January 18, 1973

ENVIRONMENTAL REPORT  
SEQUOYAH FACILITY  
KERR-MCGEE CORPORATION

SUPPLEMENTAL #2

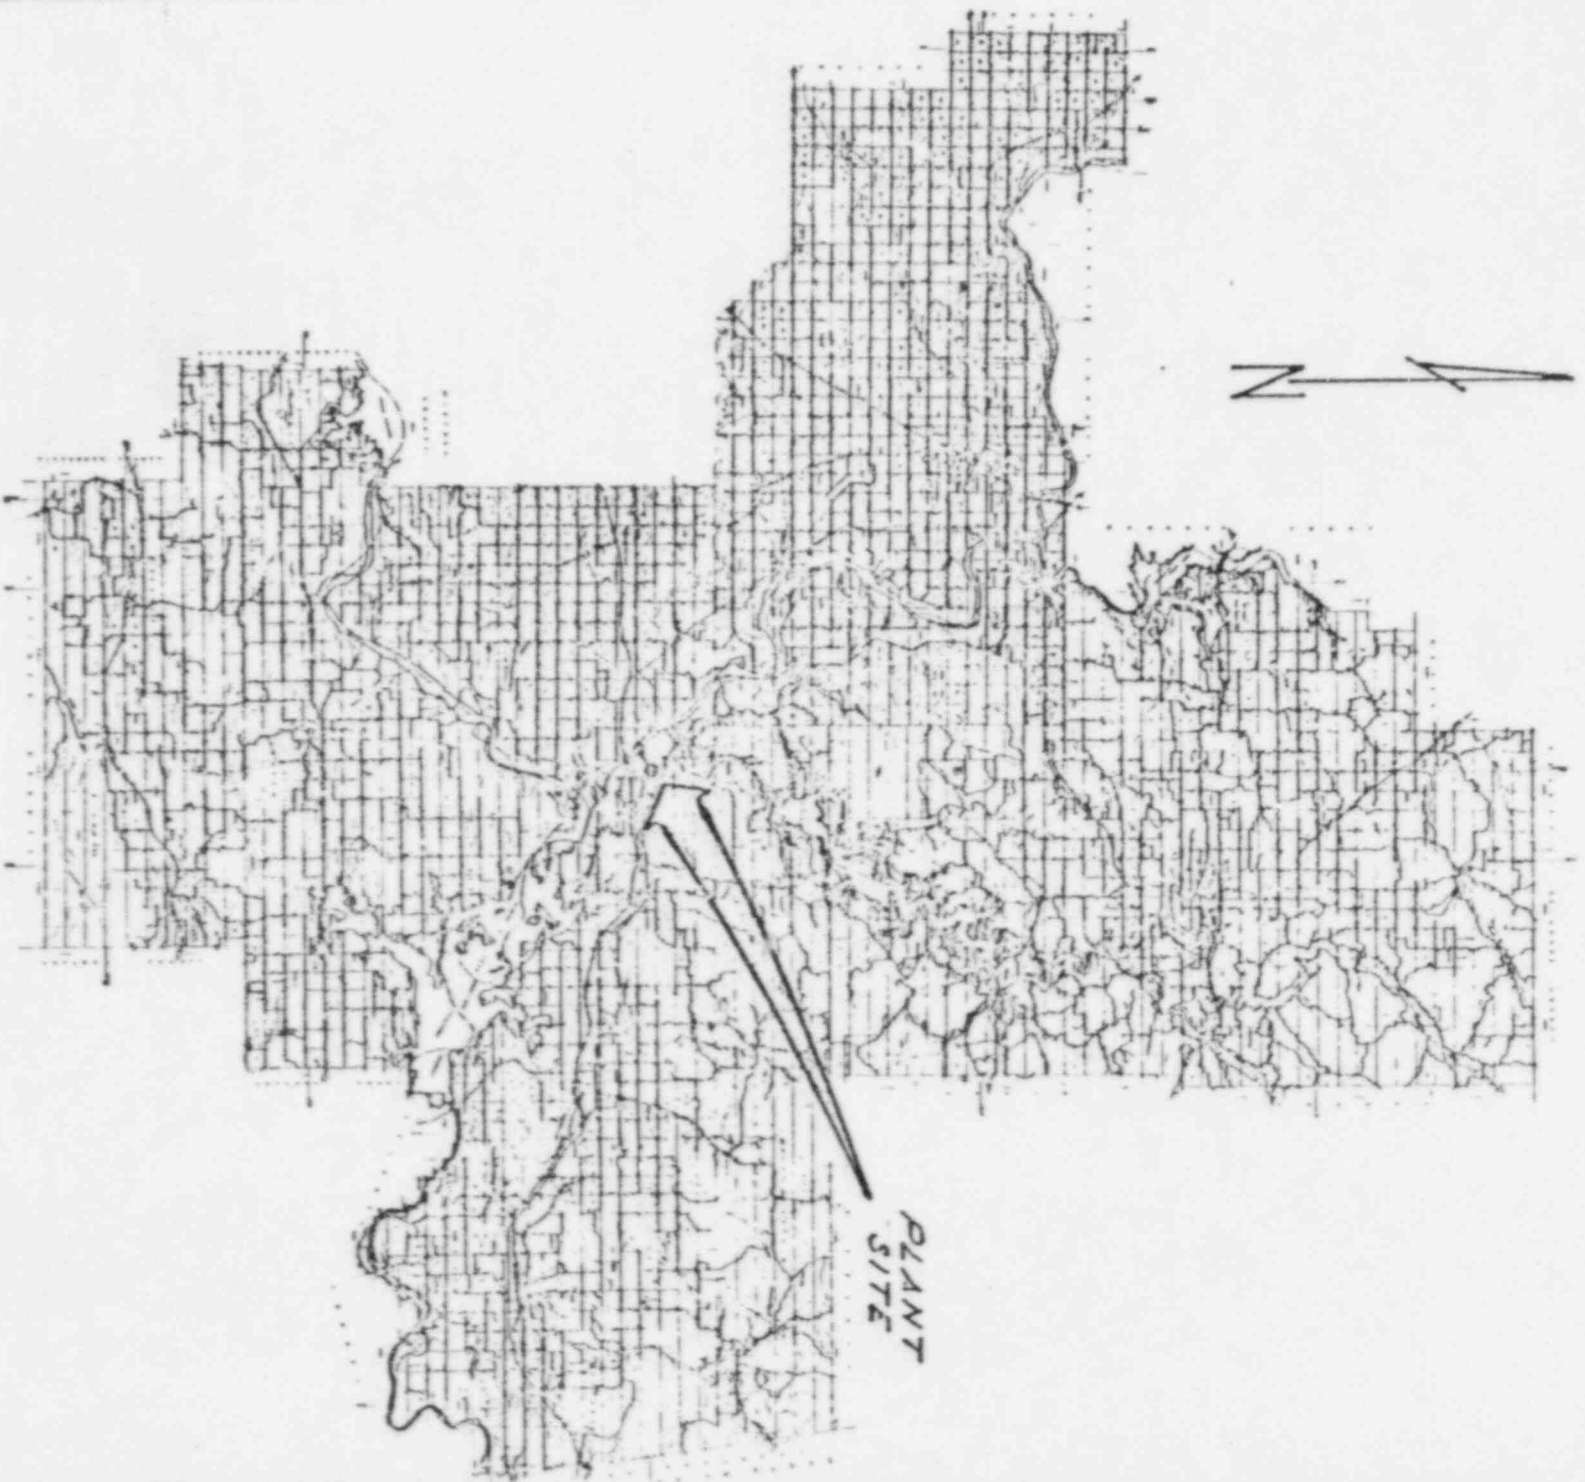
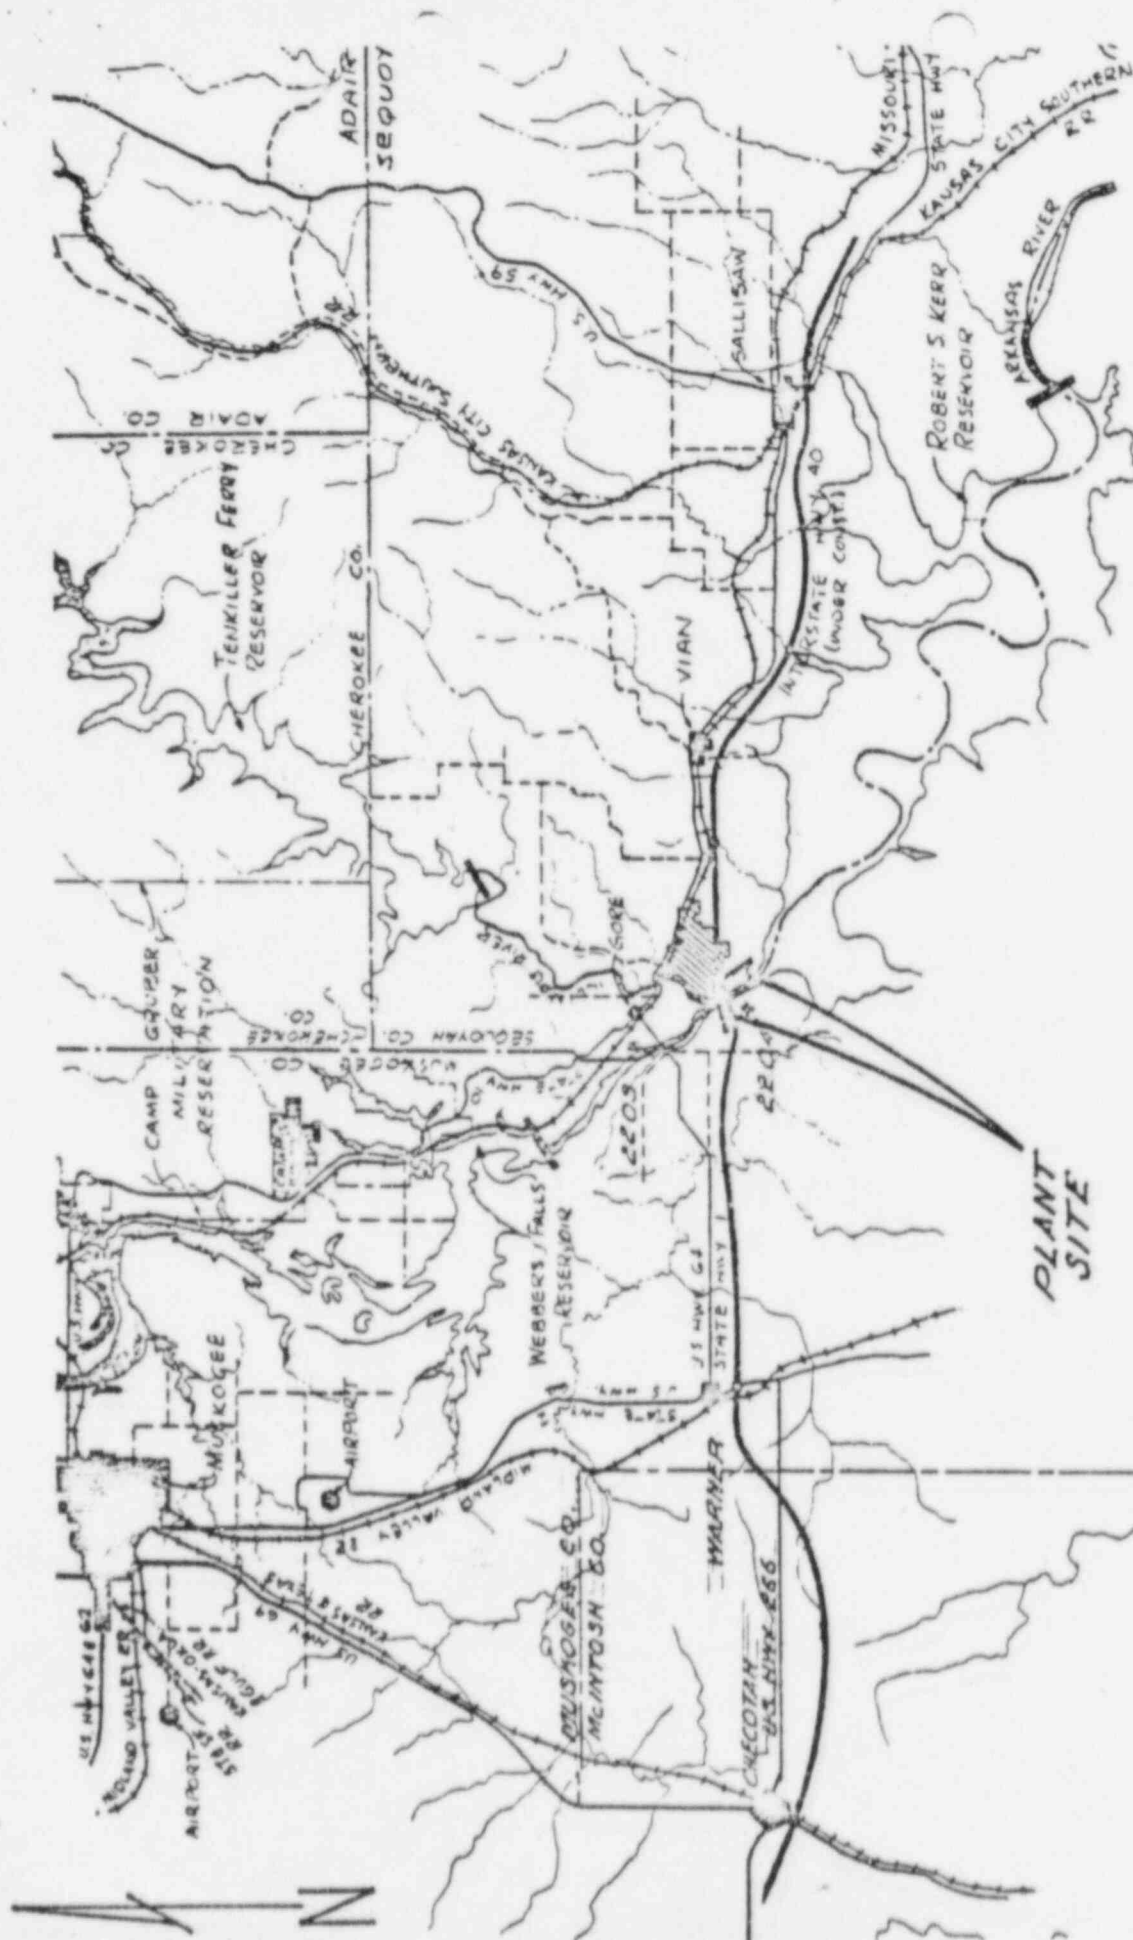
- (2) Maps provided (Figure 1 in particular) are not very clear. Suggest substituting following 8 x 10 1/2" drawings:
- (a) General map of State of Oklahoma pointing out plant site (scale about 50 miles per inch),
  - (b) Second map showing general area details i.e., towns, roads, rivers, etc. (scale about 10 miles per inch)
  - (c) Third map similar to insert in present Figure 1. (scale about 4 miles per inch)
  - (d) Plant area map (scale about 1500 feet per inch) up-dated to show all existing ponds, monitoring points, residences, etc. alone with distances from air-borne effluent release point to possible critical exposure points; e.g., school, homes, roads.

The maps requested are enclosed. We feel, however, that this request, if such fixed criteria for such reports exists, should be included in the guidelines for such reports. Figure 1 is a reduction of Drawing 110-C-151 included with the Revised Environmental Report. The location of the houses and school are circled and the distances tabulated.
